Stannah Lifts Technical Bulletin

Issue No: M1

LIFT TYPE:- HOMELIFT

DESCRIPTION:

ORG TITLE: GANTRY COMPONENTS (ASSEMBLY)		CHANGE NOTE No:	REV.
	HEAD OFFICE	DRAWN: <i>AM</i> DATE: 16/1/98	
	Anton Hill Anton Hill Rd Andover Hampshire SP10 2NX England	DRAWING NUMBER: 05300-MI	
Tel: 01264 339090 Fax: 01264 337942

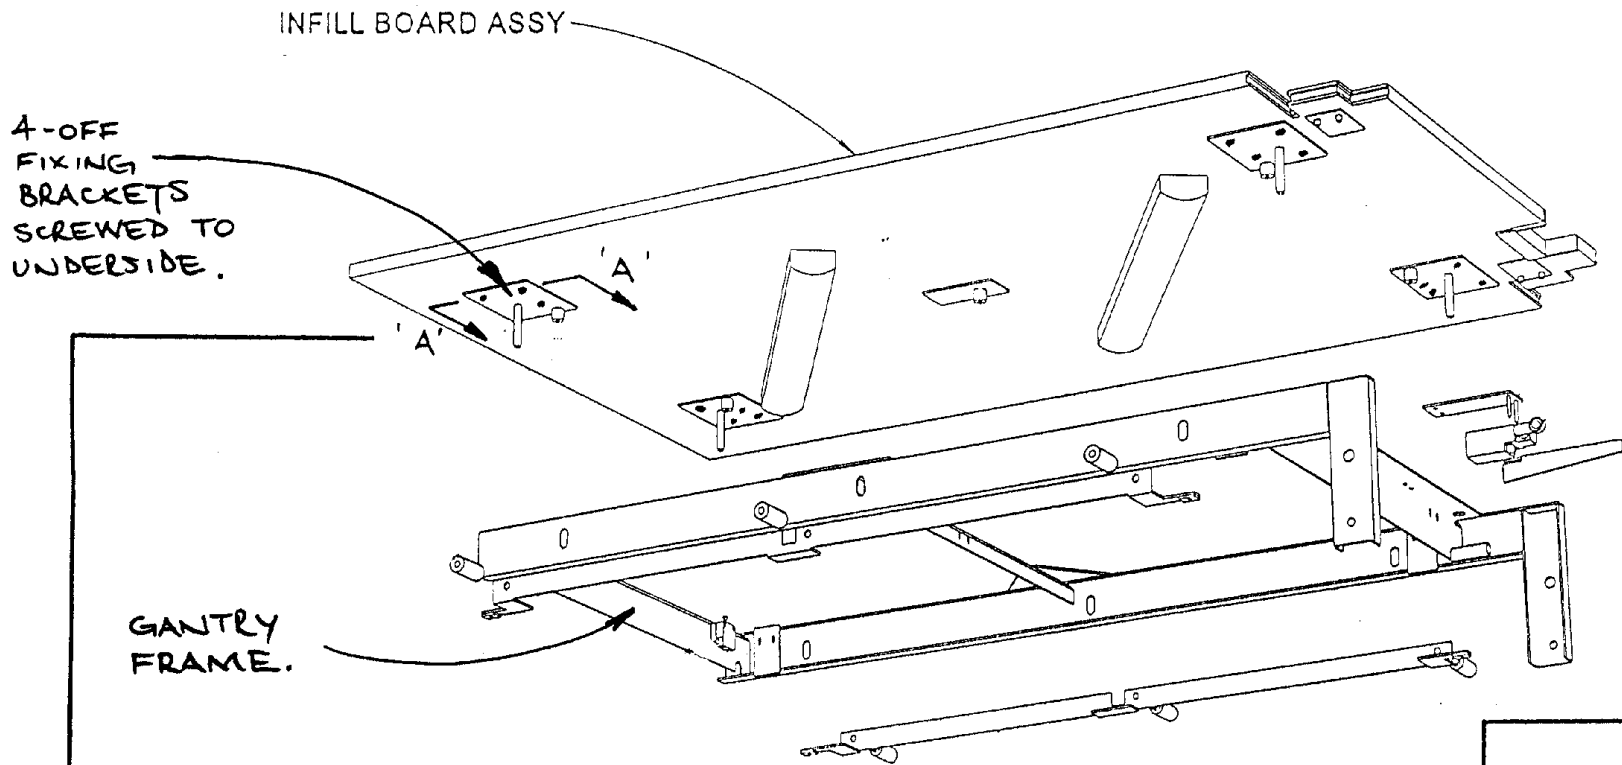
The Homelift has an infill panel, which plugs the inter-floor aperture when the cabin is at the lower floor. This infill board has four square brackets screwed to its underside for mounting onto the metal frame. On units manufactured prior to 29.11.96 these brackets were fixed using self tapping screws. It has been reported that on some installations these screws have worked loose. Although this should not create a hazard to the user it may affect the performance of the lift by activating the sensitivity switches.

A preferred method of fixing was introduced on units manufactured after 29.11.96. This is detailed on the attached drawing no. 05300-M1.

It is recommended that on any future site visits to Homelifts manufactured prior to this date that these fixings are checked. If they are found to be loose then the self tapping screws should be replaced with the M5 countersunk screws as detailed on the drawing.
